ADDENDUM 3

June 03, 2020

ITB AP 59-20

CONSTRUCT BAGGAGE HANDLING SYSTEM AND WEST TERMINAL EXPANSION – DESTIN-FORT WALTON BEACH AIRPORT (VPS)

AG0-001

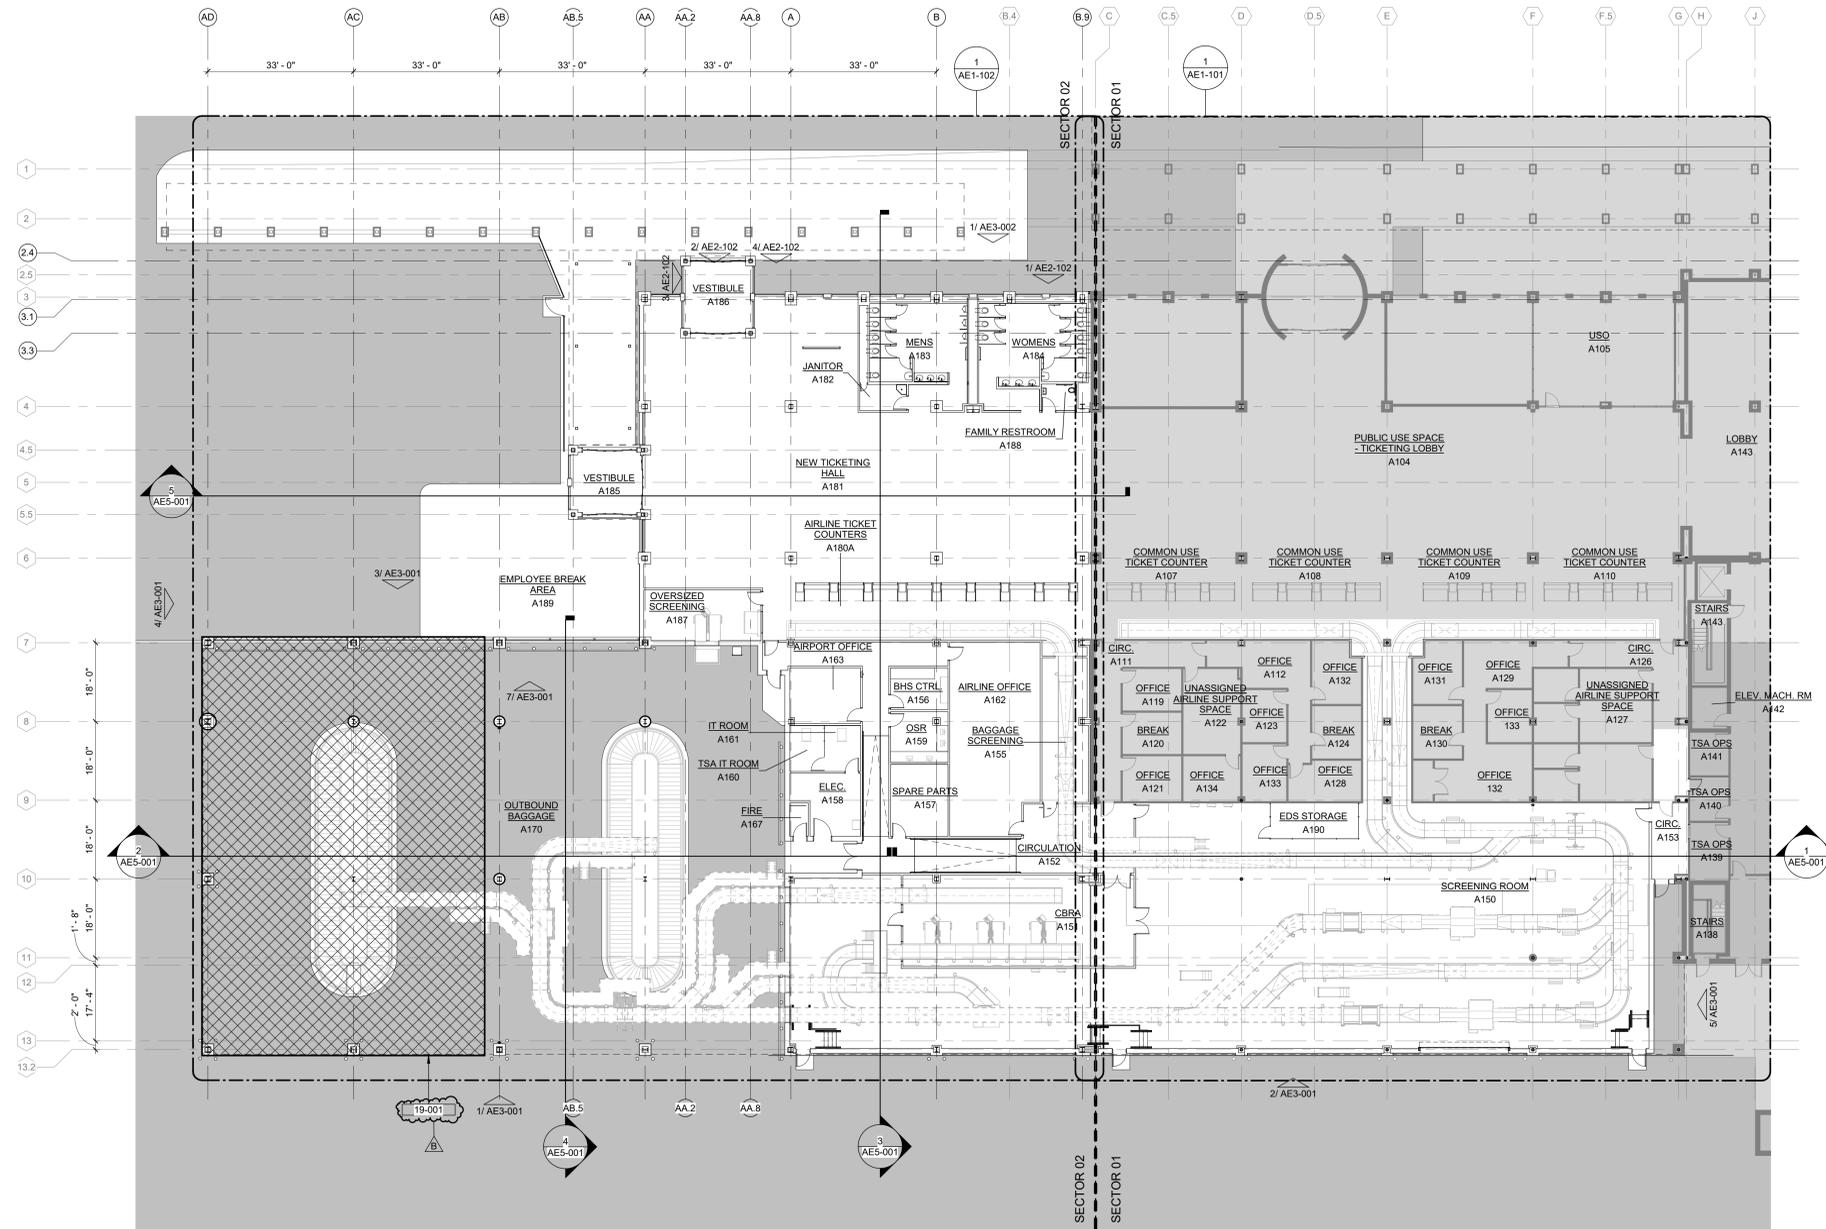
| <u>Dwg</u> <u>AG0-001</u> | Updated project data and code information. |
